QTY REQ FOR BARR RD.	ITEM NO.	NOMENCLATURE OR DESCRIPTION	DWG SIZE	PART OR IDENTIFYING NO.	SPECIFICATION	MATERIAL OR NOTE	REMARKS
LIST OF MATERIAL							
UNLESS OTHERWISE SPECIFIED DIMENSIONS ARE IN INCHES X XX ANGLES ±.03 ±.01 ±.006 ±.1/32" FRACTIONS ± ALL MACH. SURFACES ✓ RMS DRILL HOLES PER ANSI B31.1 BURRS & SHARP EDGES PER J23.115 45° CHAMFER FIRST THREAD TOLERANCES PER UNAS-135-196 GO/M TOL APPLY TO STOCK SIZES							
MATERIAL:				FINISH:			
NEXT ASSY				USED ON			
APPLICATION				E-30-43-X72-13			
SIZE		CODE IDENT NO.		SCALE		WT. GROSS	
D		02750		1/4		9N16	
SHEET 3 of 4

THE TOLEDO EDISON COMPANY
 NUCLEAR FACILITY ENGINEERING
 DOCUMENT REVIEW
 WORK MAY PROCEED
 2. REVIEW AND RESUBMIT WORK MAY PROCEED SUBJECT TO INCORPORATION OF CHANGES INDICATED
 3. C REVIEW NOT REQUIRED. WORK MAY NOT PROCEED. PERMISSION TO PROCEED ON THIS DOCUMENT, OR NOT RELIEVE SUPPLIER FROM FULL COMPLIANCE WITH P.O. CONTRACT SPECIFICATION REQUIREMENTS
 BY: [Signature]
 DATE: 1-22-78
 CONTROL NUMBER
 E-30-113-10

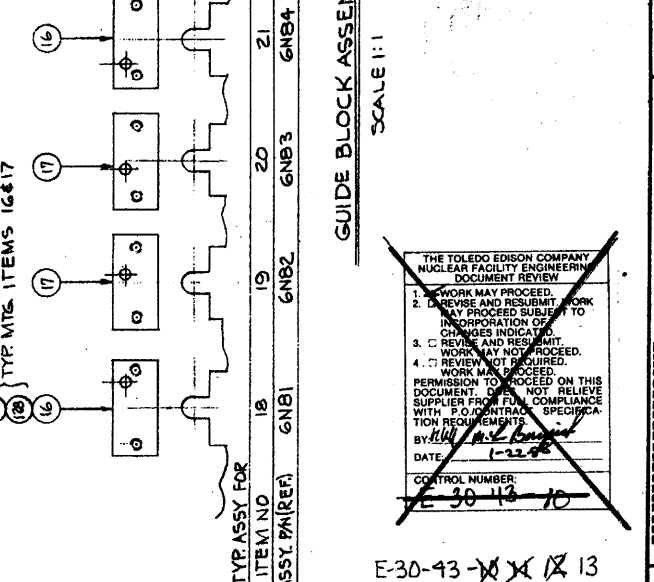
NO.	DATE	REVISIONS	BY	CHK	SUPV
T3	4/6/77	INC DCN E-30-43-7 PER FPR 94-0140-901	DMS	AW	MCS

NOTE 1: ONLY ADD DIODE & STANDOFF TO FOLLOWING:
 CABINET 9N16-1: K11E, K12L, K21D, K33C, K25C, K27I, K51D, K28L, K12B, K31C, K22D, K33D, K24C, K27J, K28H, K28M, K12G, K31E, K24C, K42E, K27K, K27L, K28I, K28N, K12H, K31F, K24D, K43A, K27G, K27L, K28J, K28C, K12L, K32A, K45E, K27H, K51C, K28K, K29D.
 CABINET 9N16-2: K11E, K31C, K24D, K43E, K27G, K51C, K28F, K29D, K12C, K31E, K32A, K25C, K27H, K51D, K28H, K12D, K31F, K33C, K24C, K27I, K28A, K28I, K12E, K21D, K53D, K27A, K27J, K28B, K28J, K12F, K22D, K42E, K27B, K27K, K28K, K12L, K24C, K43A, K27E, K27L, K28D, K29C.
 CABINET 9N16-3: K11E, K31C, K24D, K45E, K27I, K28H, K28N, K12B, K31E, K32A, K25C, K27J, K28I, K29C, K12G, K31F, K33C, K24C, K27K, K28J, K29D, K12H, K21D, K33D, K27K, K27L, K28K, K12I, K22D, K42E, K27G, K51C, K28L, K12L, K24C, K43A, K27H, K51D, K28M.
 CABINET 9N16-4: K11E, K31C, K24D, K45E, K27G, K51C, K28F, K29D, K12C, K31E, K32A, K25C, K27H, K51D, K28H, K12D, K31F, K33C, K24C, K27I, K28A, K28I, K12E, K21D, K53D, K27A, K27J, K28B, K28J, K12F, K22D, K42E, K27B, K27K, K28K, K12L, K24C, K43A, K27E, K27L, K28D, K29C.
